# Design Criteria for Multiple Spray Booths - Interpretation

# Minnesota Department of Public Safety State Fire Marshal Division

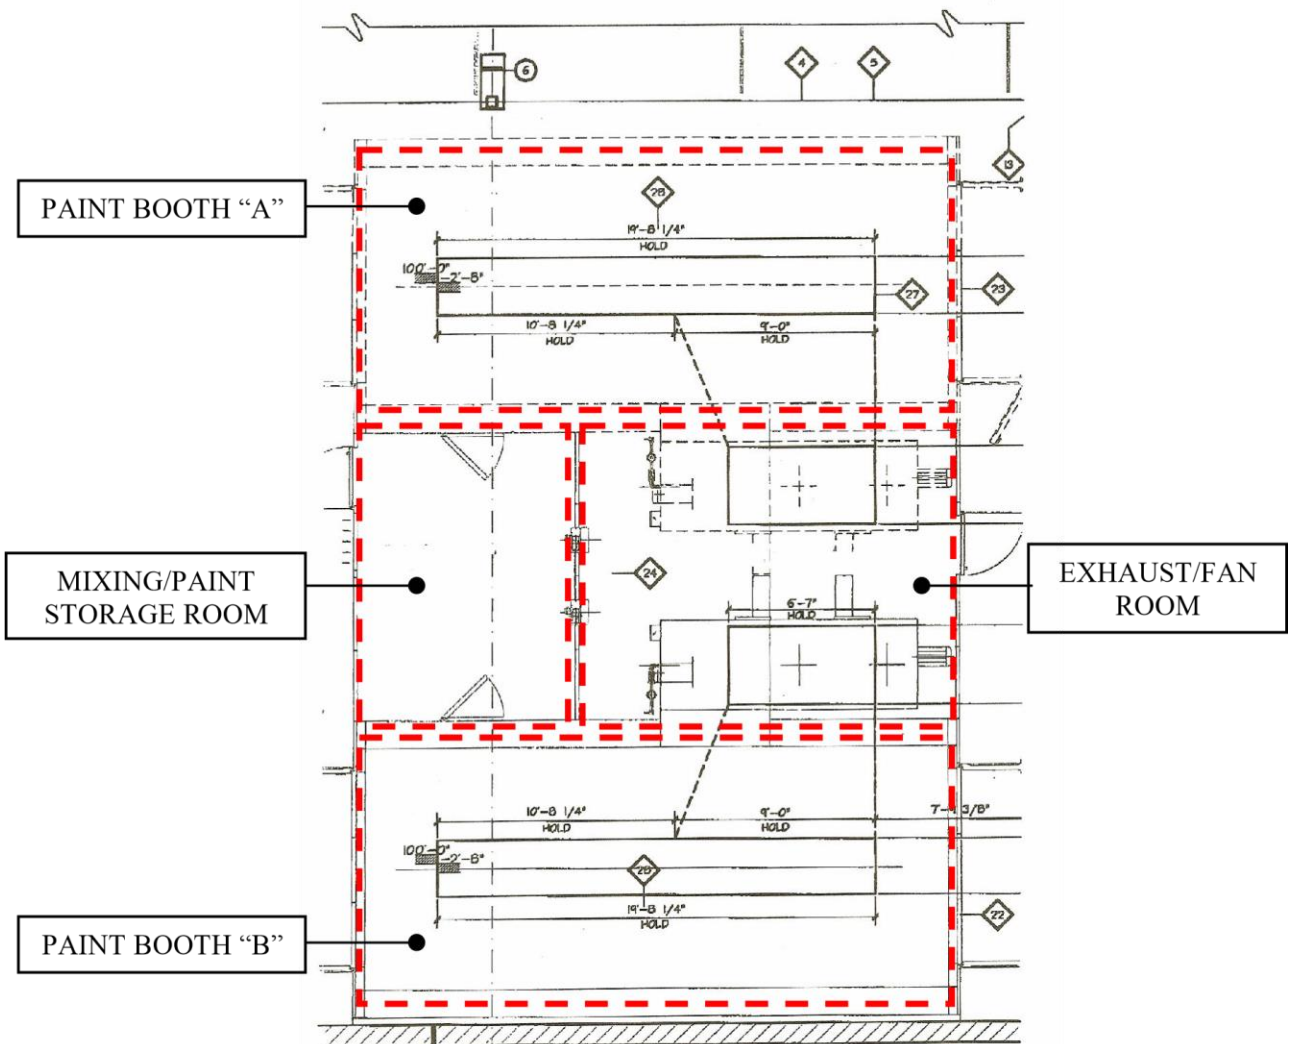
Several questions have been submitted to the State Fire Marshal (SFM) Fire Protection Team regarding the design criteria for multiple attached/adjacent spray booths. The following floor plan serves as an example:

### Question 2: Do I calculate only one booth at a time or do I calculate the entire spray area as an Extra Hazard Group 2, 0.4/2000 (in this case the full 1,080 sq. ft.)?

**Question 3: Assuming in Question 2, the whole area needs to be calculated; a new twist is if the booths are not attached to each other. How far apart do they need to be to become separate booths and calculated individually: 1 inch, 1 foot, 5 feet...etc.?**

**Answer:** Design the hydraulically most demanding single booth and associated exhaust ductwork to Extra Hazard Group 2. The single booth calculations are independent and do not have to be added to the overhead system calculations.

Attached booths with openings in common wall(s) are considered as one single booth. Example: Two booths have a common wall with a walk through opening. The door of the opening consists of strips of heavy plastic material commonly found in coolers and freezers. For calculation purposes, the entire area of both booths shall be considered as one booth. If the door of the opening is of material consistent with the remainder of the booth, for calculation purposes this would be considered as two independent booths.

**Answer:** The whole area is not required to be calculated (refer to Question 2). It is important to note that MSFC Section 2404.3.3.5 requires that booths have a 3 foot clearance.
